** STAFF REPORT AMENDED 7/20/83 DESIGN REVIEW & PRESERVATION BOARD

LOCATION: 507 13th Street

PROPOSAL: Addition at the rear of a 3 unit residential structure listed on the Official Register as a Priority Structure.

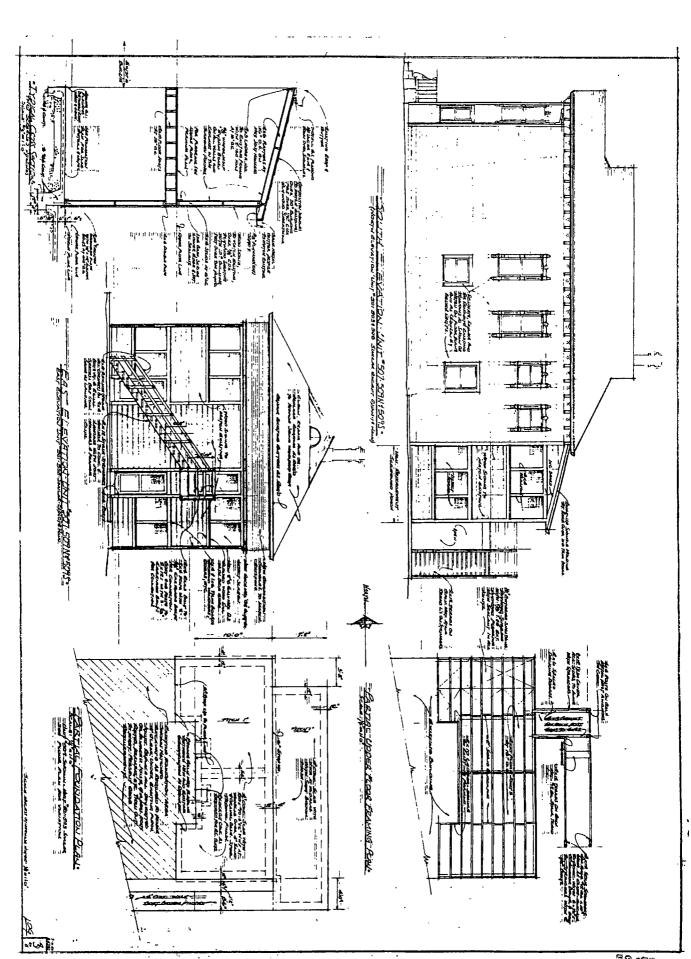
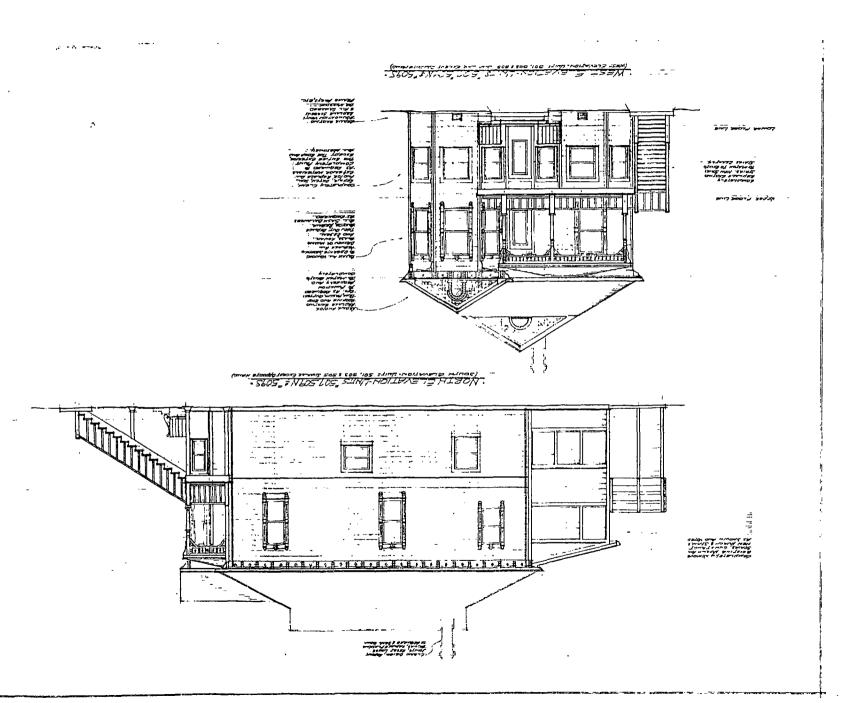
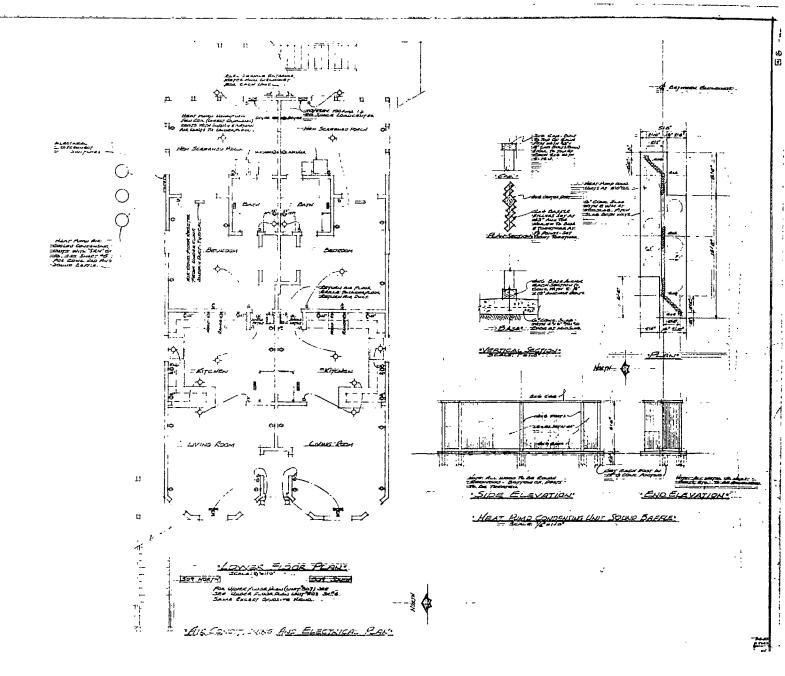
- 1. Proposed interior modifications and enlargement of the screened porches are intended to improve the livability of the units. Nevertheless, the addition will increase the prominence of the least attractive element of the structure's exterior.

- 2. Presently the rear porches detract from the aesthetics of the Priority Structure to the east (1310-12 E Street). The addition will do further aesthetic harm to the adjacent structure.

- 4. Should, however, the Commission approve the variance request and the Board approve the addition, staff suggests that:
 - a. The stairs be set against the face of the addition in order to minimize the degree of encroachment toward the rear and the adjacent Priority Structure.

- b. The color of the building should not be white. A less reflective color that is also compatible with the structure at the rear should be used.
 - c. Horizontal siding matching the main structure shall be used.

7/20 ACTION: APPROVED WITH AMENDED CONDITIONS
